# Metro Martin Place

## Over Station Development Design Integrity Report

### North Site

NOVEMBER 2020

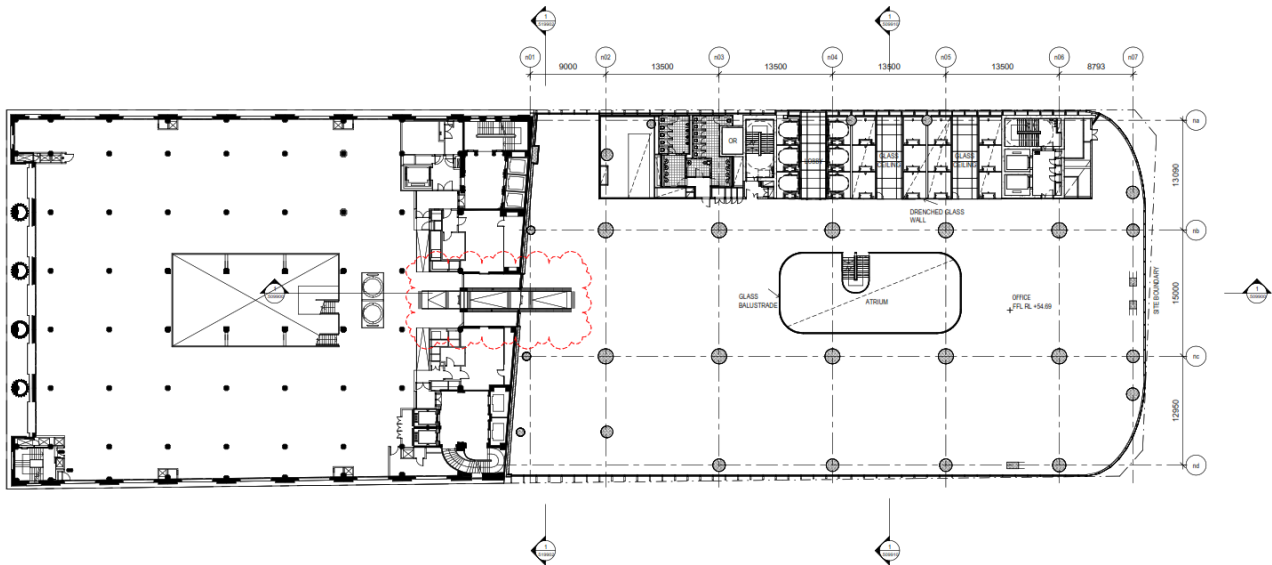
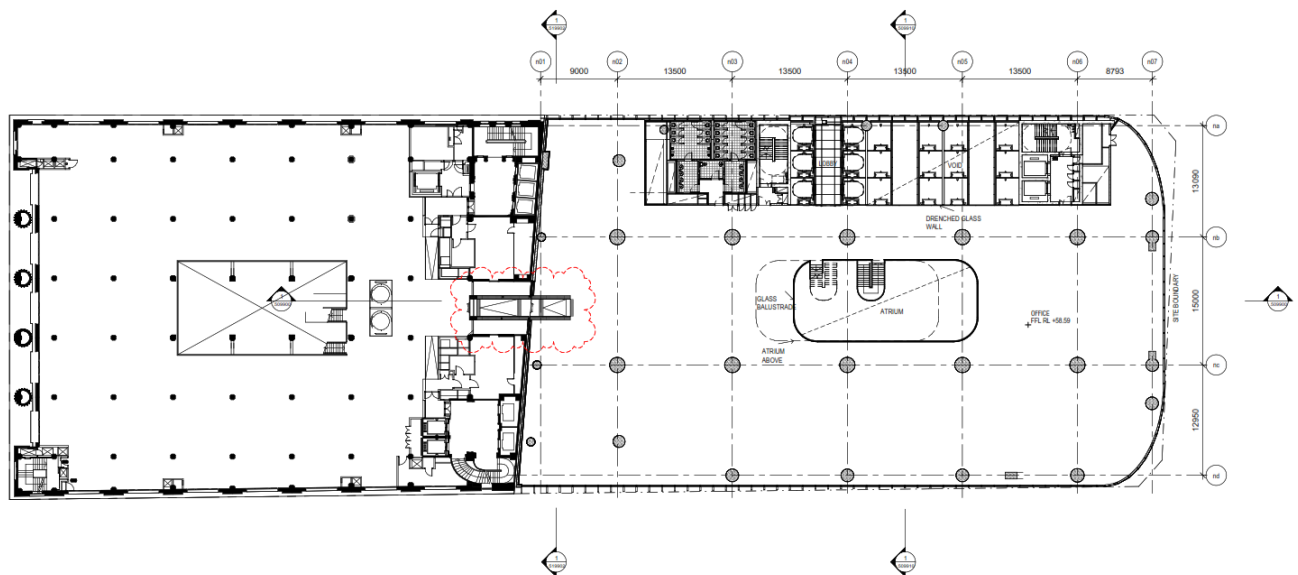
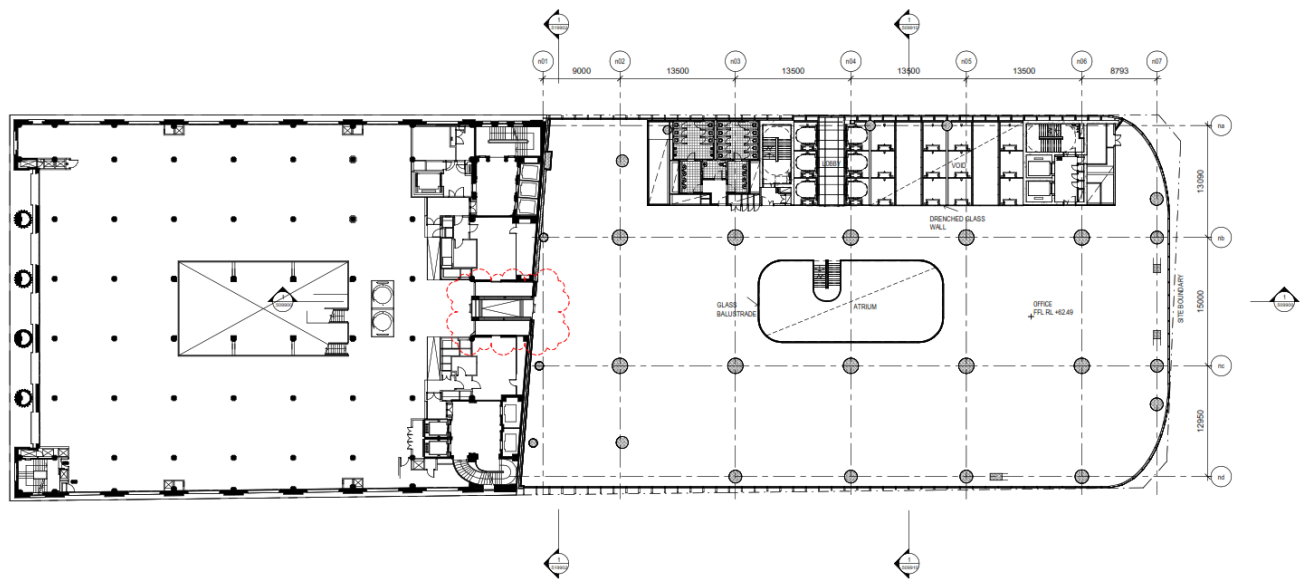
OSD DRP Advice	Macquarie Response
Panel confirmed its support in principle of the design of the bridge links and of the introduction of three additional links, noting the proposed connections are logical and necessary. It was noted that the bridges have been designed to be removable and that the design would be subject to detailed recommendations from the Heritage Council.	Macquarie welcomes the OSD DRP's in principle support for the proposed amendments.
<ul style="list-style-type: none"><li>Noted that the Nikki Savvas artwork will be relocated.</li></ul>	Noted.
<ul style="list-style-type: none"><li>Finishes will match those in 50MP, all bridges are currently intended to have the same finish.</li><li>Opportunity to look at the materiality of the soffits.</li></ul>	Noted and will be further developed through detailed design in the lead up to construction certificate drawings.
<ul style="list-style-type: none"><li>L10 glazed element will continue across and connect to the opposing slab – element still in development.</li></ul>

- Noted that the Nikki Savvas artwork will be relocated.
- Finishes will match those in 50MP, all bridges are currently intended to have the same finish.
- Opportunity to look at the materiality of the soffits.
- L10 glazed element will continue across and connect to the opposing slab – element still in development.
- Advice from Macquarie noted as follows: that a Section 4.55 modification would need to be lodged with DPIE. The Heritage Office will be referred the modification as part of the statutory process, however Macquarie has undertaken early engagement with heritage to ensure in principle support for the bridge links prior to progressing the proposal too far.

### THROUGH SITE LINK EAST/WEST SECTION

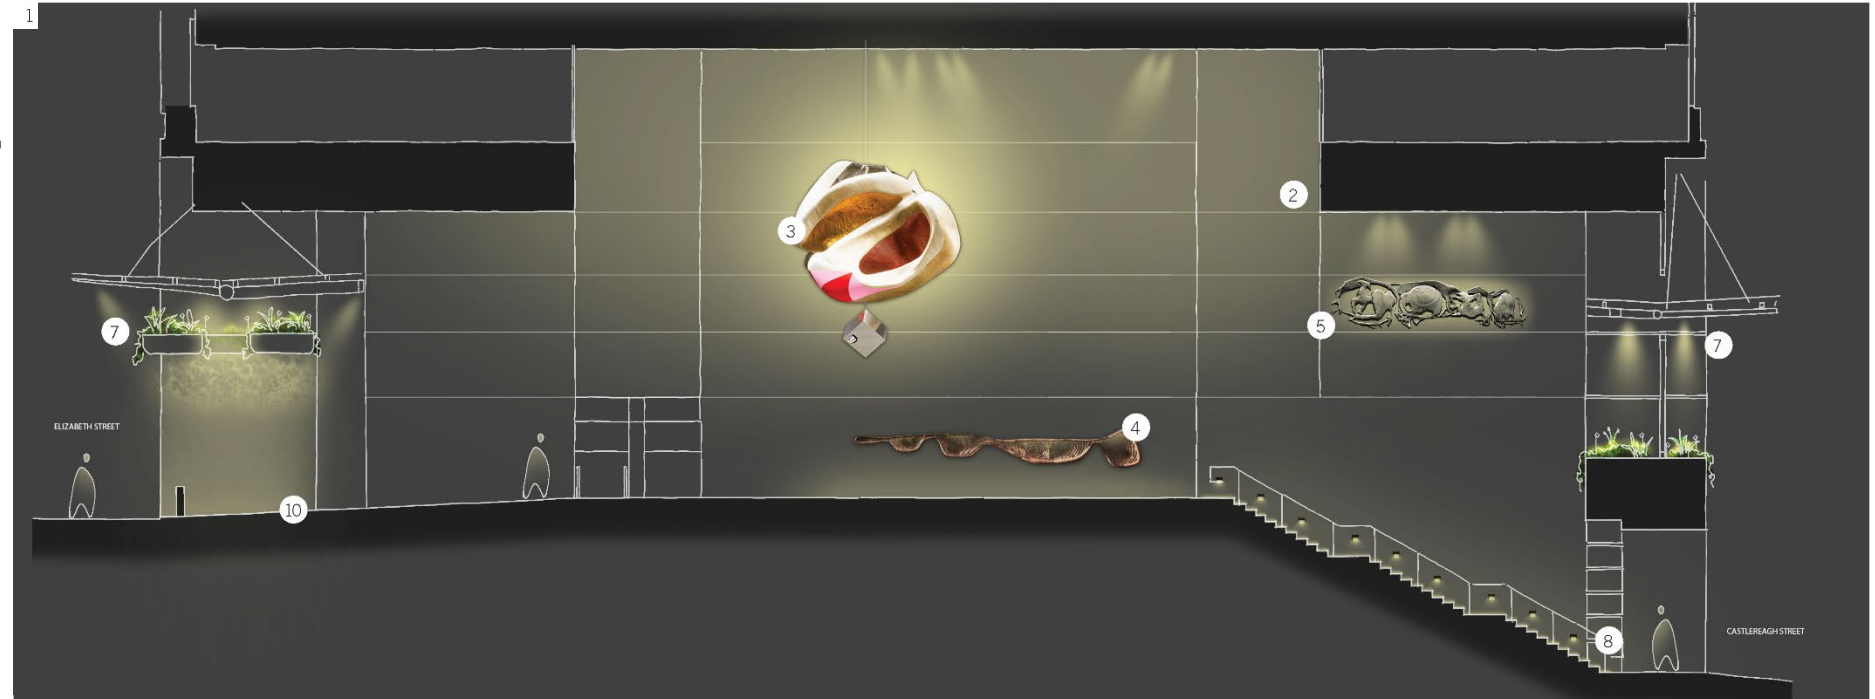
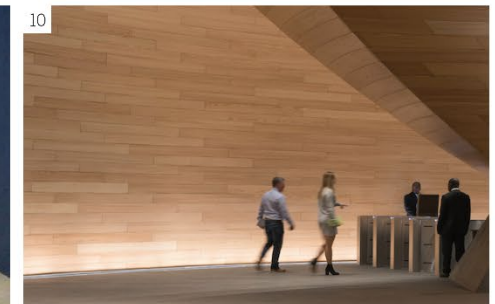
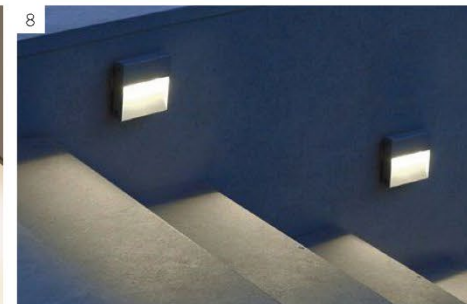
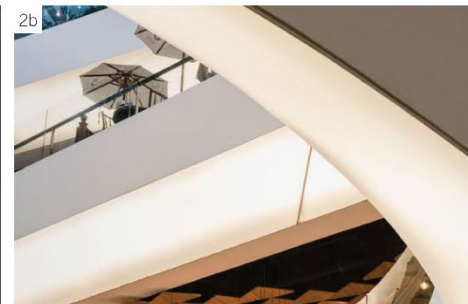
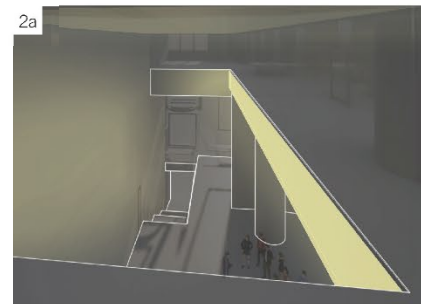
(e) A level of design finish suitable for a busy publicly accessible space	<i>For comment</i>
<b>DRP minutes</b>	<b>Through Site Link</b> Information is yet to be provided to demonstrate that the expression of the through site link will realise the ambition to provide a grand public room distinguishable from the Macquarie lobby (such as the continuation of the stone cladding from the outside in, legibility of connections into the station and lobby spaces, accessibility and public character)	<i>For endorsement</i>
	<b>Materials</b> The panel notes the proposed material selection continues to be refined in response to environmental and other issues raised by the panel and we look forward to seeing further richness and patina in the selected materials	<i>For endorsement</i>
